CONVAIR

COMMERCIAL CHANGE PROPOSAL

SPEC NO.: ZD- 22-003

CUSTOMER: Delta Air Lines Inc.

12-PLACE CLUB AREA

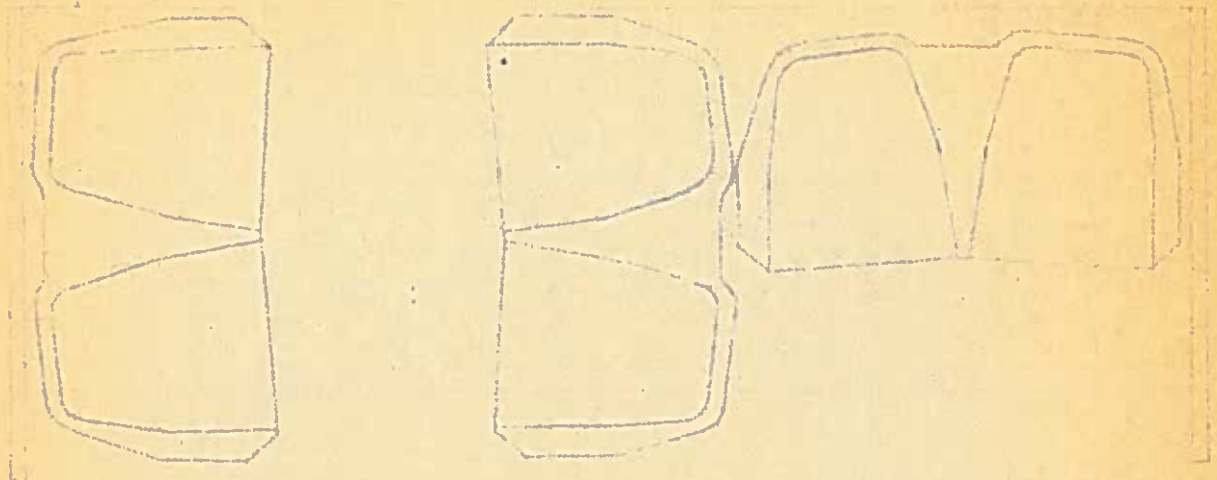
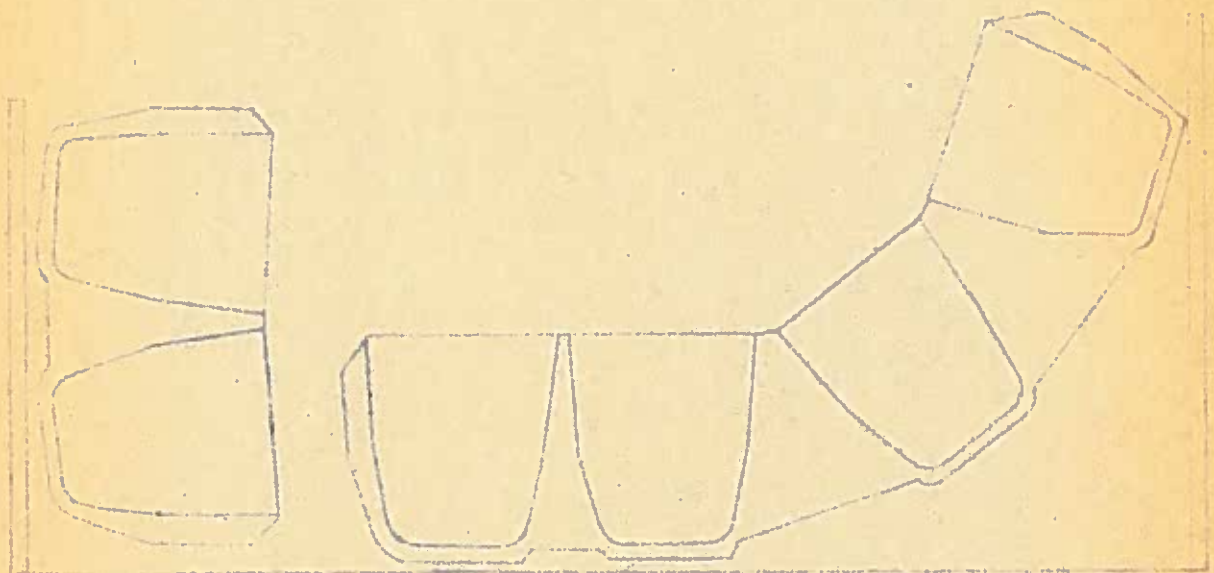
"The standard 84-passenger configuration (including 12 club area passengers) shall include full provisions to permit quick conversion to a full range of mixed class interiors utilizing the two coat compartments shown in Figure 1-3 as dividers. These coat compartments shall be designed to utilize the standard floor seat attach

points and thus may be placed in any of the rows between rows six and fifteen inclusive, excluding emergency hatch areas, in the main cabin section. Each of the 22 seat rows shall incorporate standard cabin windows, and each row aft of the club area shall have reading lights and individual air outlets for five abreast seating as shown in the coach configuration in Figure 1-3. All rows shall permit the installation of standard seats or coach seats. Provisions shall be made for installation of a left and right hand hat rack in the club area for use with four and five abreast seating arrangements."

Revise above figures as required to reflect this change.

Enclosure: (A) One (1) copy of sketch of proposed Club Area Arrangement.

FIGURE 3.12-5

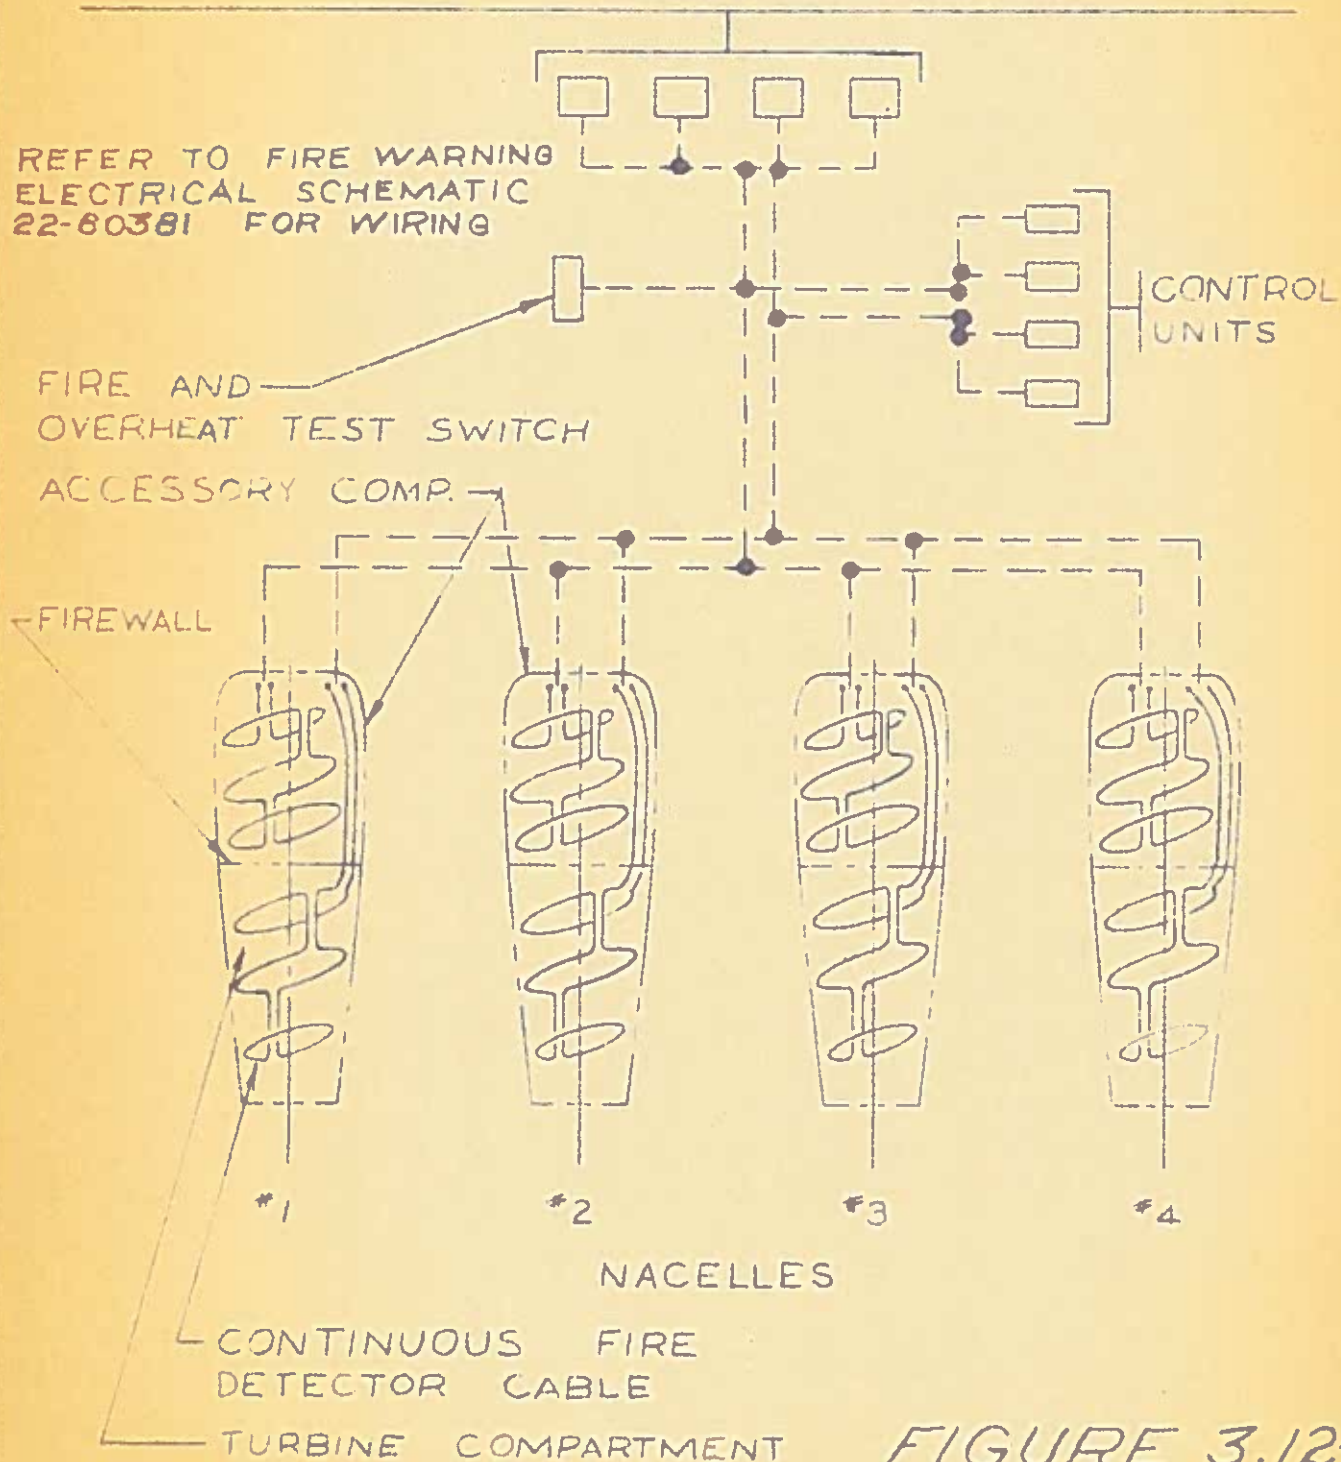
Figure 3.12-5 FIRE DETECTOR SYSTEM, ENGINE NACELLES

Enclosure (A): One (1) copy of Figure 3.12-5 FIRE DETECTOR SYSTEM, ENGINE NACELLES (Revised 1-23-58).
